CITY OF ALBUQUERQUE

RE: **Lot 17 Block 5 S.A.D. 227 Unit 5**
7028 Victoria NW
Grading and Drainage Plan
Engineers Stamp Date 8/10/2020 (E10D081)

ENGINEER'S SEAL	LOT 17 BLK 5 UN 2 VC 7928 VICTORIA DRIVE, N.W.	DRAWN BY	DATE
		DATE	8-7-20
	GRADING AND DRAINAGE PLAN	LOT 17, BLK 5 UN 2 VC.DWG	
8/10/20	 <i>Rio Grande Engineering</i> 1606 CENTRAL AVENUE SE SUITE 201 ALBUQUERQUE, NM 87106 (505) 872-0899	SHEET #	C1
DAVID SOULE P.E. #14522		JOB #	_____

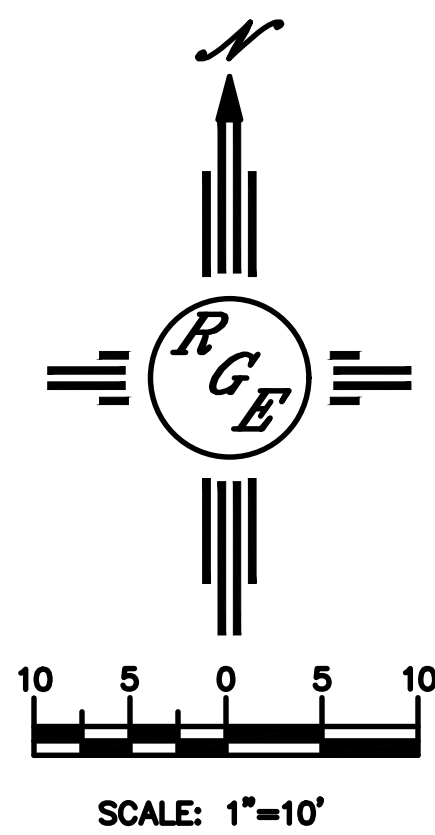
Based upon the information provided in your submittal received 8/10/2020, this plan is approved for Grading Permit. Please inform the builder/owner to attach a copy of this approved plan and letter into the construction sets in the permitting process prior to sign-off by Hydrology.

Reiterate to the Owner/Contractor that a separate permit for any garden/retaining wall must be obtained, with the approved G&D plan.

Prior to Building Permit approval, a **Pad Certification** will be required. Inform the contractor/owner not to pile dirt in the street as a ramp to climb the curb. If dirt is found in the street the pad cert. will be denied.

Prior to **Certificate of Occupancy release**, Engineer Certification per the DPM checklist of this plan will be required.
